MANDATORY SERVICE BULLETIN Z 126/31a

1. MODELS AFFECTED: All the Z 126 aircraft and the Z 26 aircraft with metal empennages.
2. SUBJECT: Due to the sporadic occurrence of loosened bearing on the countershaft that connects both halves of the elevator on the Z 126 aircraft, applicability of the Bulletin Z 226/3 of August 22, 1958 is extended to the aircraft mentioned above (Sect. 1).

Bulletin of the Z 226 aircraft.

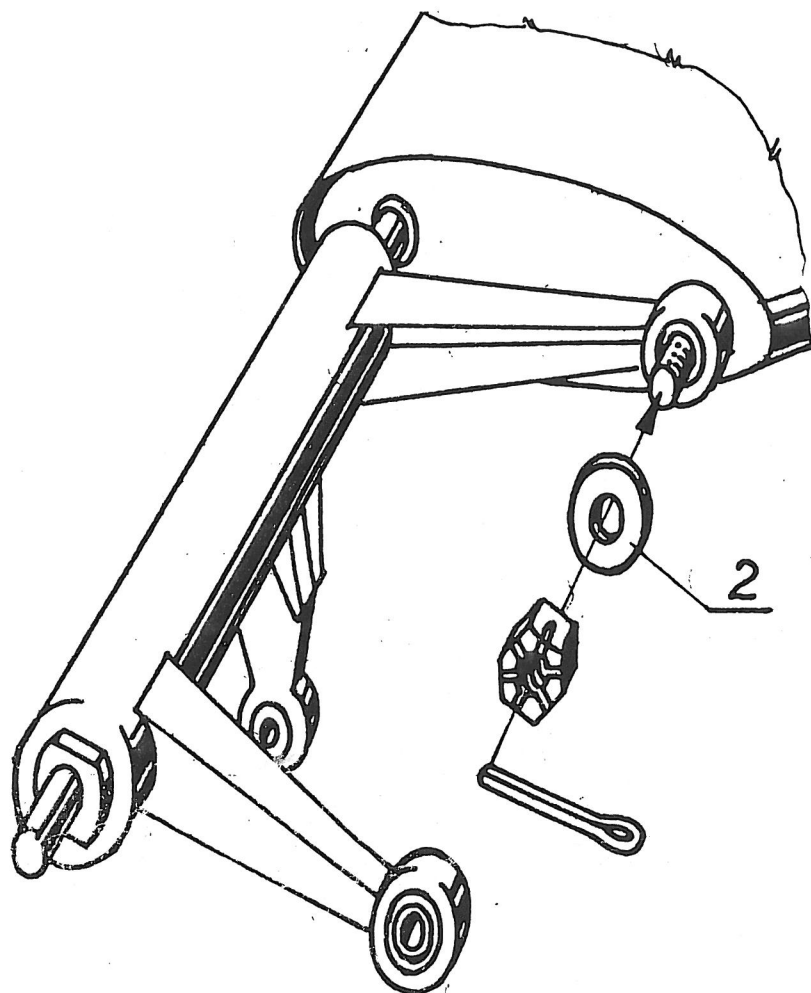
In order to prevent it it is necessary to change the original washer 6 ČSN - 313282.12 (List of spare parts pos. No. 2) under the castle nut for the new one of a greater diameter with prod. No. Z 326.322-03.

In the event of the washer cannot bear on the bearing on account of the welds in fork it is possible to modify the washer (see the drawing).

3. CORRECTION: Check diameter of washers (Item 2 in Figure in the Bulletin Z 226/3). If the washer dia. is smaller than the bearing outer ring dia. (ϕ 14 mm), it is necessary to replace it with the washer ϕ 16 mm.

The parts delivered for exchange : 2 pcs washer Z 326.322-03 for 1 aircraft.
